147 Major St — HVAC clash mark-up

HVAC Designs LO# 113963 (HVA 26 167838) vs permit 26 167838 BLD 00 · PalmView BIM review · Oct 22, 2026

PALMVIEW CLASH REVIEW · OCT 22, 2026

Sheet Title
BASEMENT HEATING LAYOUT

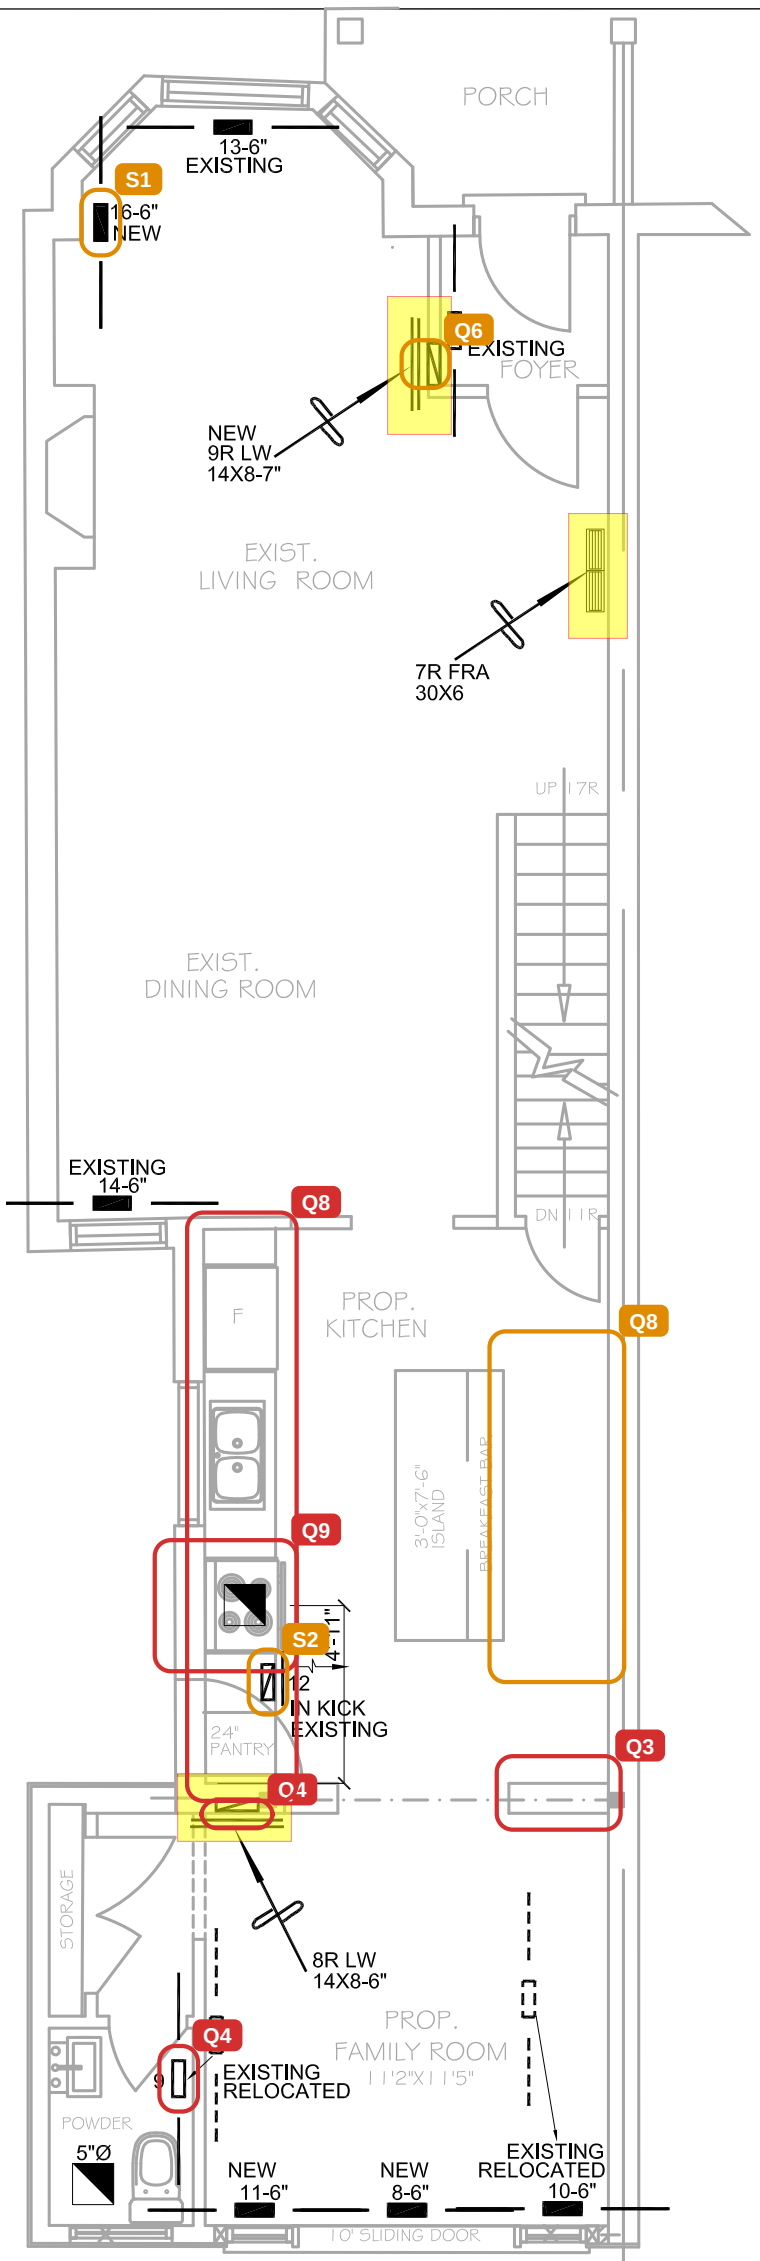
Core three holes in the brick, or route all rear branches through the existing 30" opening. Owner: HVAC sub. Status: OPEN.

Both stacks land on top of existing masonry (powder E wall, pantry/storage double wall). Relocate. Owner: HVAC Designs. Status: OPEN.

All stick out 3–4" past the studs. 3-1/4x14 stacks, 2x6 walls, or chases. Owner: HVAC sub / framer. Status: OPEN.

F-1 not tagged existing and sits where the permit shows the existing H.E. furnace. Takeoff runs over the tank vent. Owner: PalmView. Status: OPEN.

Q3 Rear branches 8, 10, 23 through the old rear foundation

Q4 Supply 9 and return 8R sit on old foundation walls

Q6 7" return stacks in 2x4 walls (1R–6R, 9R) and 6" supply stacks

Q10 F-1 new or existing; hot water tank vs plenum

S3 Trunk E ends ½" off the old rear wall

Sheet Title
FIRST FLOOR HEATING LAYOUT

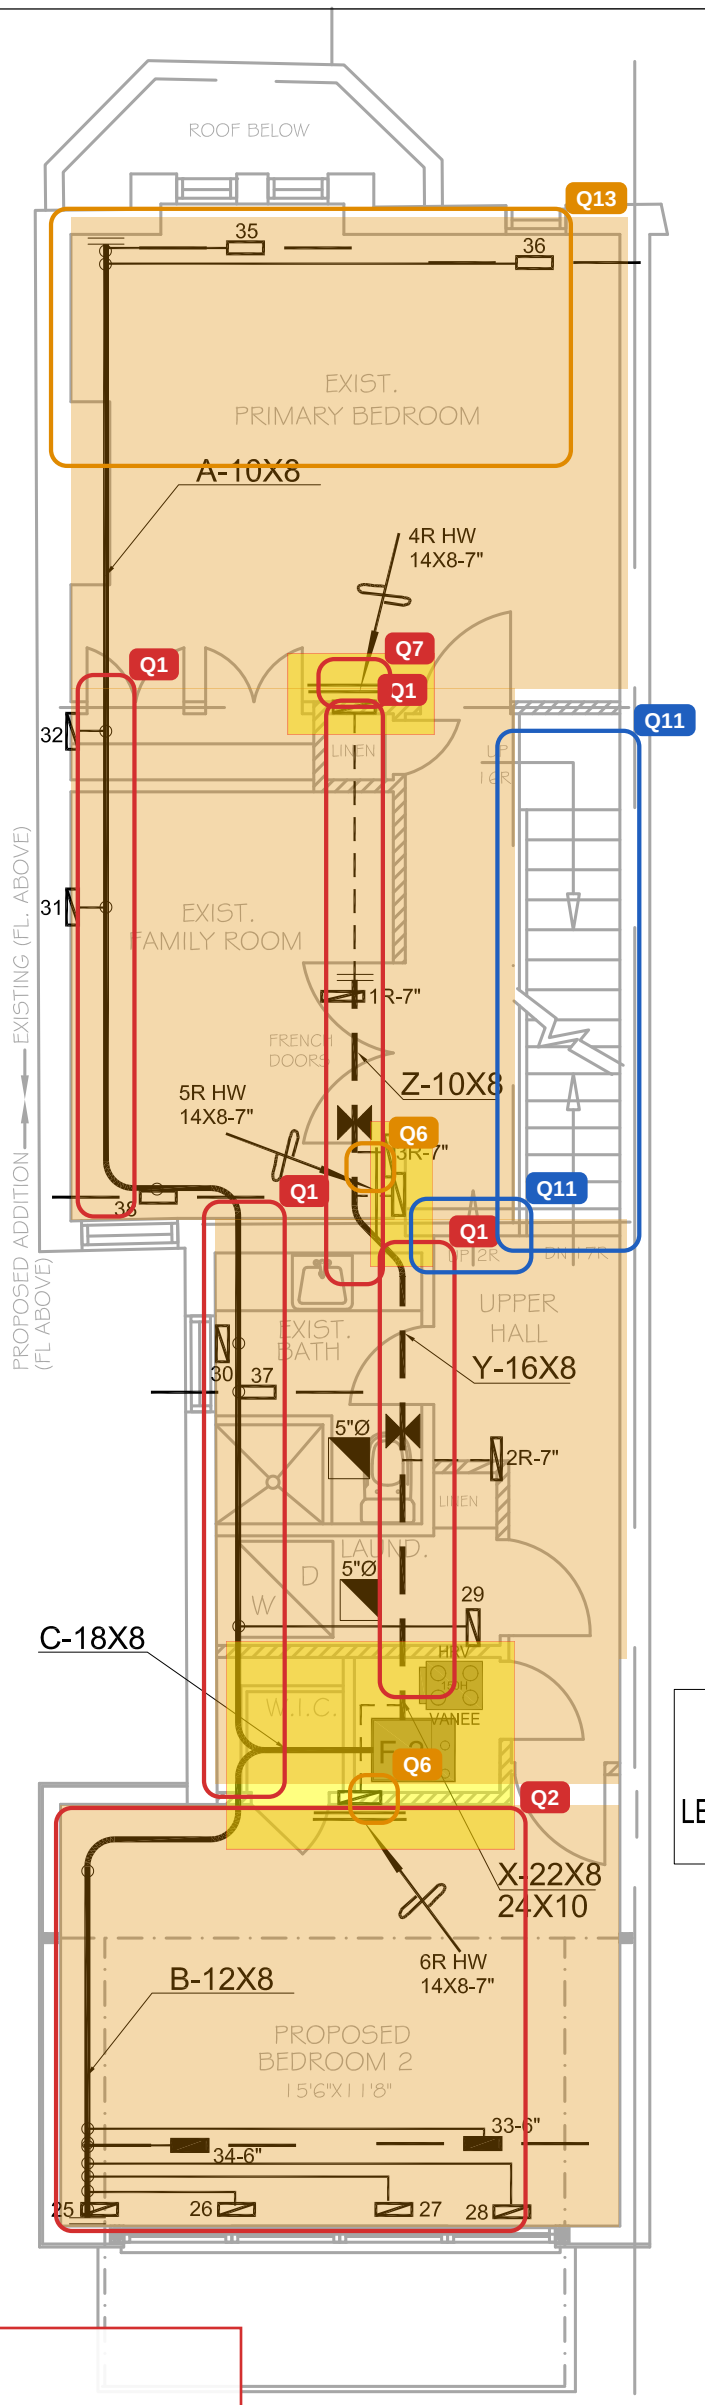
Permit shows a 30" range and 34" fridge; Miele range and fridge are 36". Cabinet set 186.5" vs 184.6" wall. Aisle to the stair is 34.9". Owner: Cabinet shop / PalmView. Status: OPEN.

Elica Trento insert on the south wing wall under the 2nd-floor overhang. No duct or termination drawn. Owner: HVAC Designs. Status: OPEN.

- Q3 Rear branches 8, 10, 23 through the old rear foundation
- Q4 Supply 9 and return 8R sit on old foundation walls
- Q6 7" return stacks in 2x4 walls (1R–6R, 9R) and 6" supply stacks
- Q8 Kitchen sizes: range, fridge, run length and aisle
- Q9 Kitchen hood exhaust not designed
- S1 Supply 16 boot tight to the bay corner
- S2 Supply 12 kick register under the pantry

Sheet Title
SECOND FLOOR HEATING LAYOUT

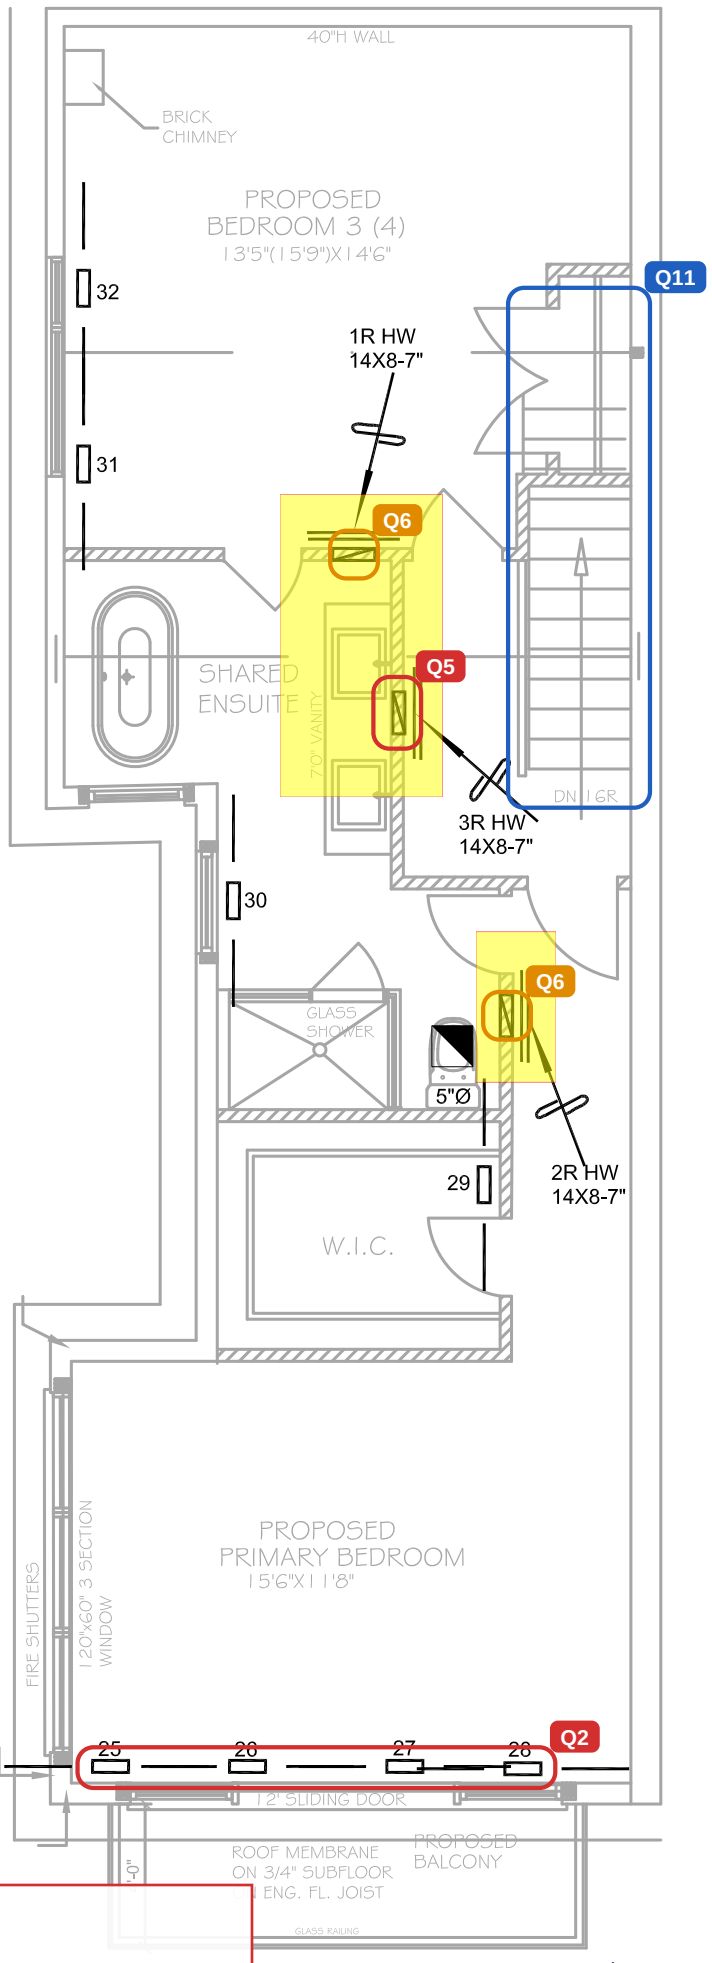
Rear (lower) level, 10'-4½" ceiling: drop the hall / bath / laundry / W.I.C. / bedroom 2 ceilings flat to ~9'-6" to hide C, B, Y, 6R and branches 25-28, 33/34 (or box them at 9'-8"). Front (upper) level, 9'-0½" ceiling: trunk A along the south wall and return Z in the family room need 14" bulkheads at 8'-4", or a reroute. Owner: PalmView / client. Status: RESOLVED.

Confirm the cantilever TJIs over bedroom 2 run front-to-back (balcony). Trunk B sits on the south LVL1; 5 branches cross 26 cantilever joists. Owner: Kott / Rona + engineer. Status: SITE.

Grille is on the closet wall right under LVL5; the stack cannot pass the beam. Owner: HVAC Designs / engineer. Status: RESOLVED.

Plans A8/A9: new stair stacked over the existing one, rising front-to-rear. Section A-A draws it rising rear-to-front. Step: section A-A framing shows 16" (2R at 8"); the rear and south elevations show 1'-9" (10'-11" vs 9'-2"). Model uses 16". Owner: PalmView / designer. Status: OPEN.

Trunk A (first 6.7 ft) and branches 35/36 are under the existing front roof. If that space is outside the insulation, ducts need R-12 + Class A sealing (permit note). Owner: PalmView. Status: OPEN.

Q1 2nd-floor ceilings for the F-2 trunks

Q2 Bedroom 2 ceiling: joist direction and trunk B on LVL1

Q6 7" return stacks in 2x4 walls (1R–6R, 9R) and 6" supply stacks

Q7 Return 4R stack vs the LVL5 flush beam

Q11 Stair direction 2nd → 3rd, and the size of the 2nd-floor step

Q13 Front roof space over the primary bedroom

Hung under the joists, three runs moved off wall top plates: trunk C 2" east (was 1.4" into the notch wall), return Y 5" east (was over the bath east wall), 6R run and stack 5" east (was over the W.I.C./mech wall). Still to place on site: the C-to-A tie (10x8 at the step line) lands between the family-room rear wall and the bath north wall, which are only 7.8" apart - box it on the family-room side.
